HISTORIC PRESERVATION COMMISSION

ALTERATION TO A HISTORIC PROPERTY STAFF REPORT

Site:	178 Central Street	c.1840 Adams-Locke House
Case:	HPC 2014.014	Single Building Local Historic District
Applicant Name:	Serge Roy, Owner	
Applicant Address:	178 Central Street	
Date of Application:	March 2, 2016	
Legal Notice:	<i>Replace concrete pathway with pavers.</i>	
Staff Recommendation:	Certificate of Appropriateness	
Date of Public Hearing:	April 19, 2016

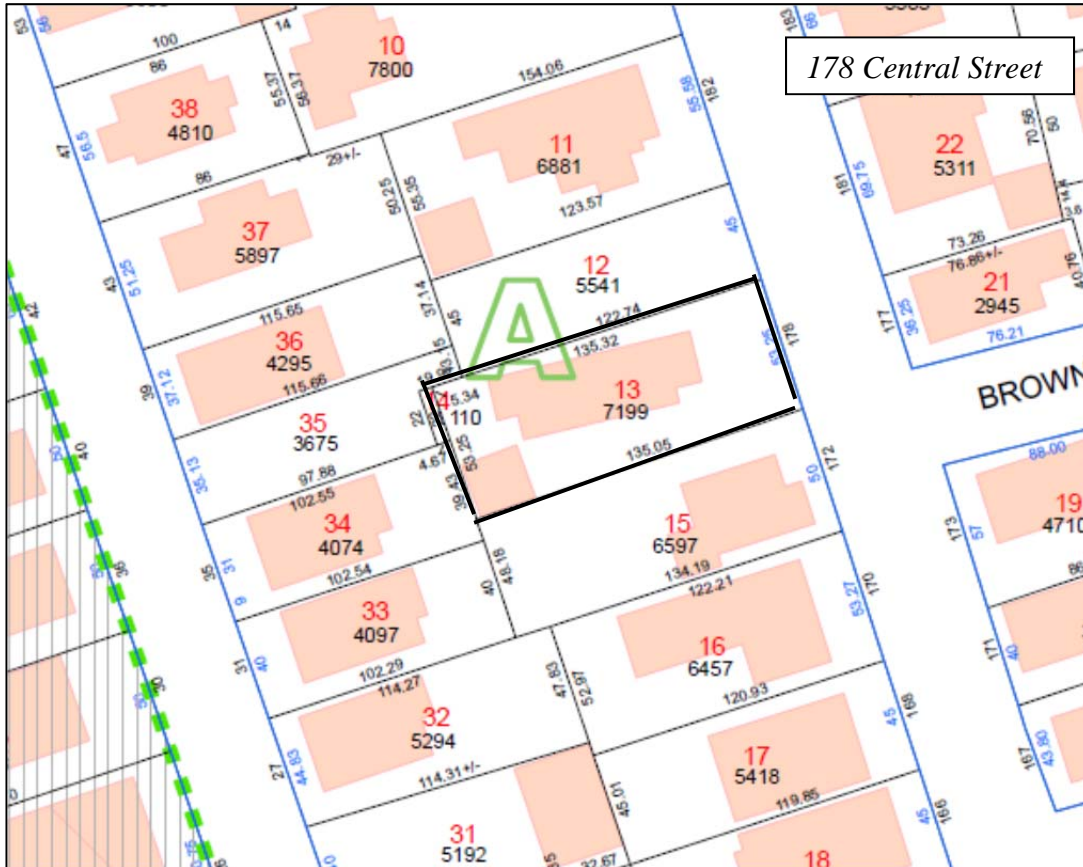
There are no alterations to the essential landscape features. There are no changes to the layout of the pathway. The new brick pathway will not alter the essential integrity of the house or the district. The Applicant would like to lay a decorative herringbone pattern with edging.

1. Applicant shall obtain all appropriate building permits prior to commencing work.
2. The walkway shall retain the current dimensions, alignment and location.
3. The walkway shall have real brick pavers to be laid in a herringbone pattern with an edging pattern as indicated in the attached photos.
4. If the approval differs from the plans, new plans shall be submitted to Historic Staff prior to commencing the work.
5. Historic Staff shall issue a sign-off upon completion of the project that this was done in accordance with the Certificate and approved plans.
